GOVERNMENT OF INDIA  
MINISTRY OF ENVIRONMENT, FOREST & CLIMATE CHANGE  
**Central Zoo Authority**

F. No. 22-2/2007-CZA(NS)/7890

**Sub:- Layout Plan of Ambardi Wildlife Interpretation zone and design of proposed construction of Animal Upkeep Centre, Visitors' gate and emergency gate and design of proposed strengthening of toe wall of perimeter fence at Ambardi Wildlife Interpretation zone (Ambardi Safari Park)-Reg.**

PLAN

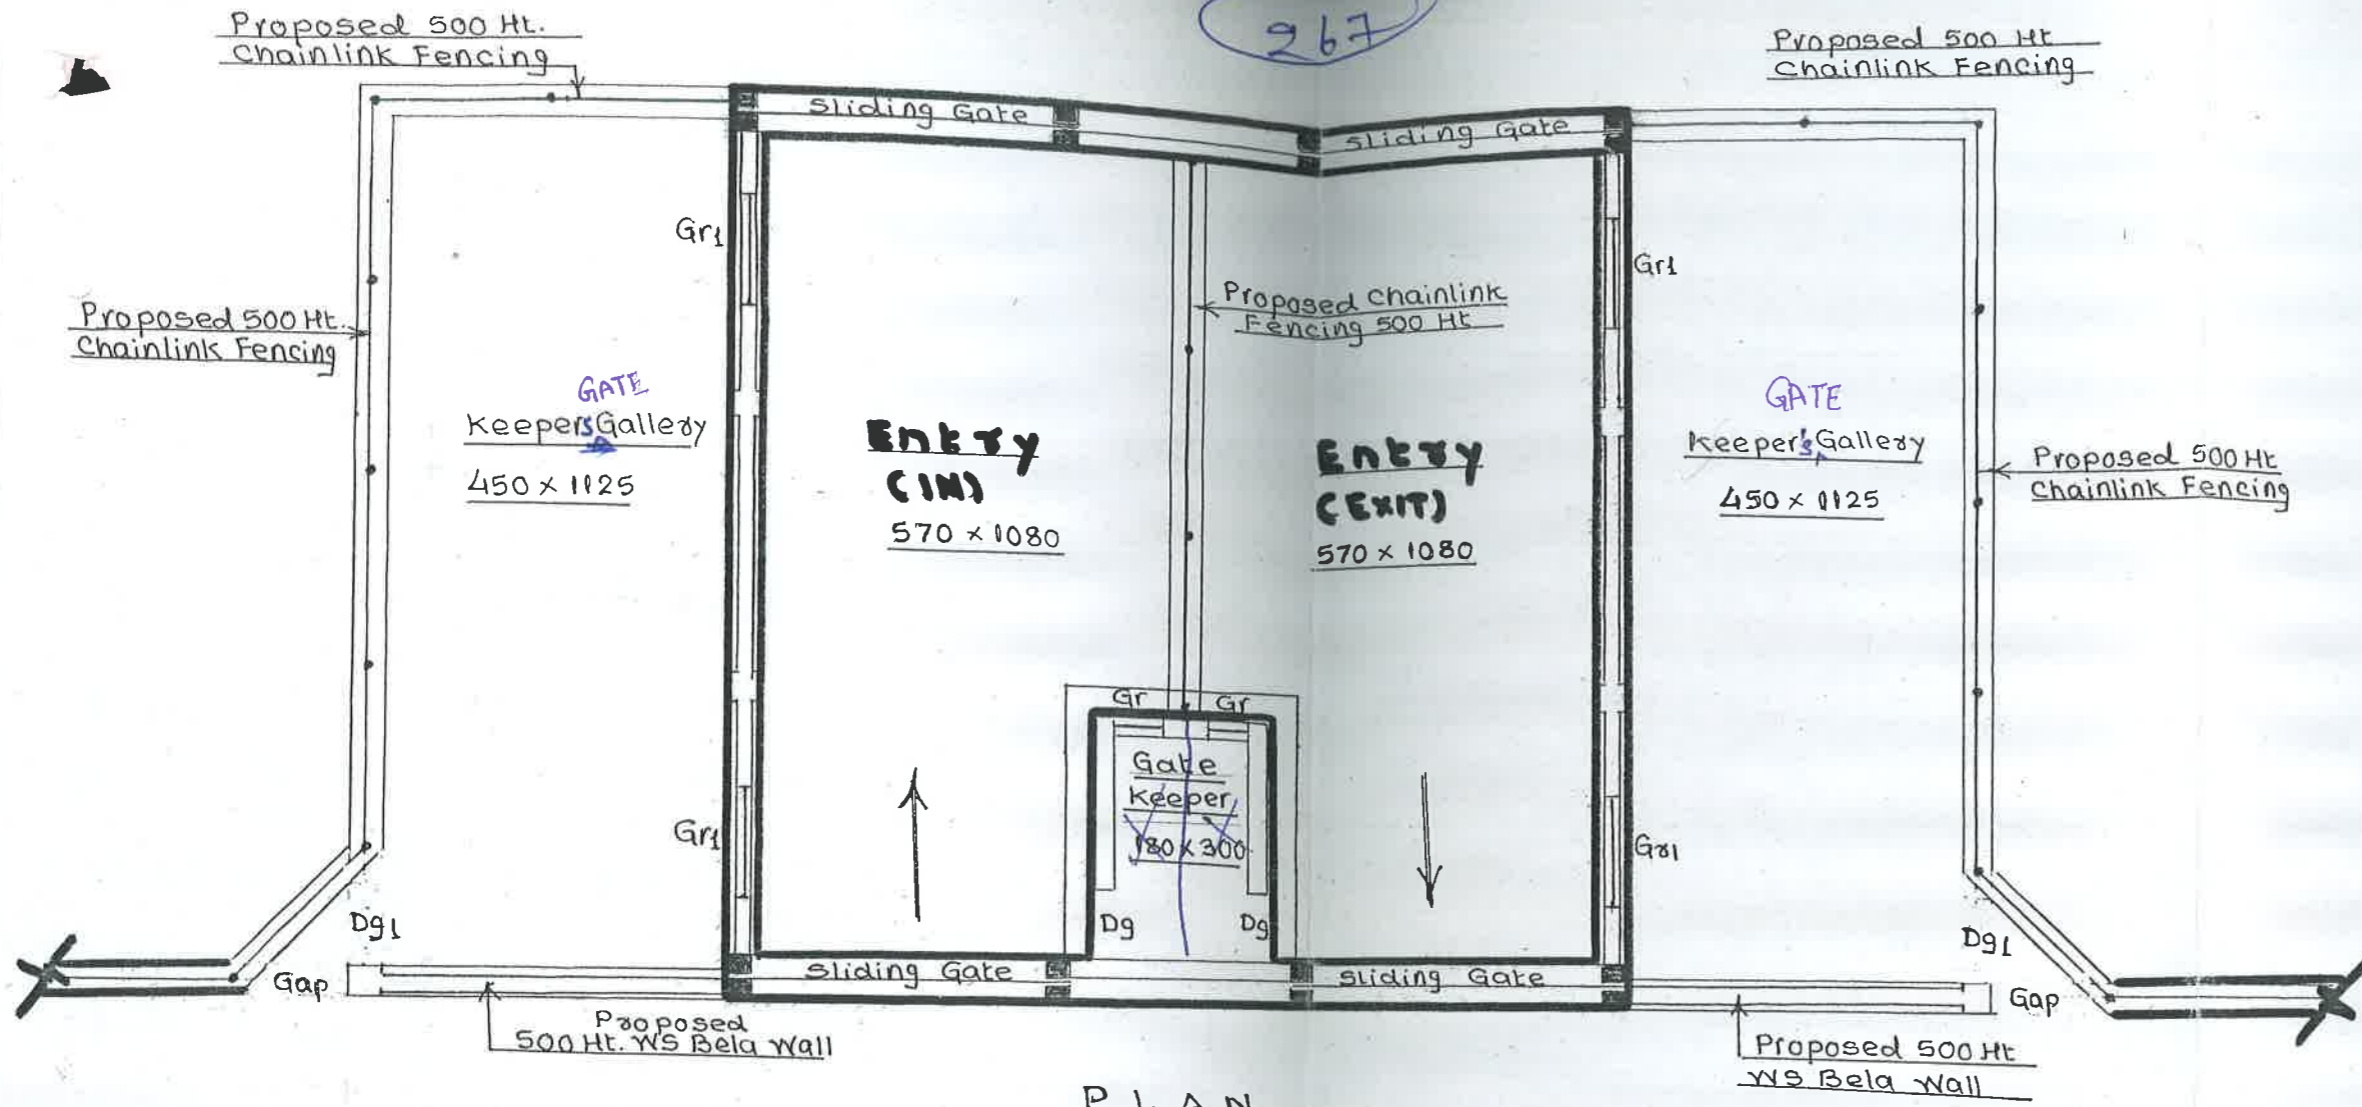
Members, on scrutiny of design of proposed construction of Animal Upkeep Centre, as such is approved. However, made following observations:

1. Width of keeper's gallery is too much. Gallery with 3 meter width should be sufficient.
